**Replacement Stabilizer Bar Bushings –  
Lubricate Before Installing**

**MODEL**  
1997 MY-ON XK Range  
1998 MY-ON V8 XJ Series  
**VIN**  
001001-ON  
812256-ON

ILLUSTRATION 1

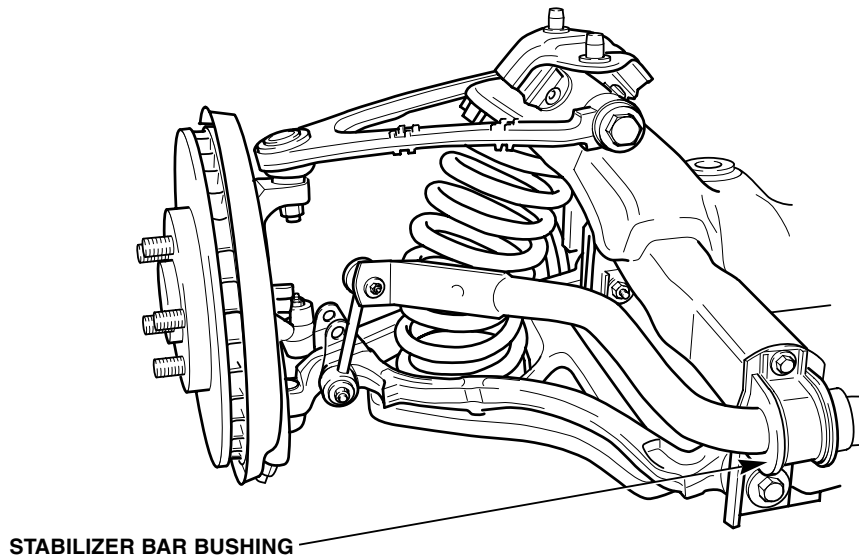
When replacing the front or rear stabilizer bar mounting bushings, apply Castrol NTR grease part no. 10558 to the inner face of the bushing. This action is required to allow free movement of the stabilizer bar within the bushings.

**⚠ Caution:** When applying the grease make sure that only the inner face of the bushings is coated with the grease. Grease applied to the outer face of the bushings will affect the retention of the bushing by the retaining brackets.
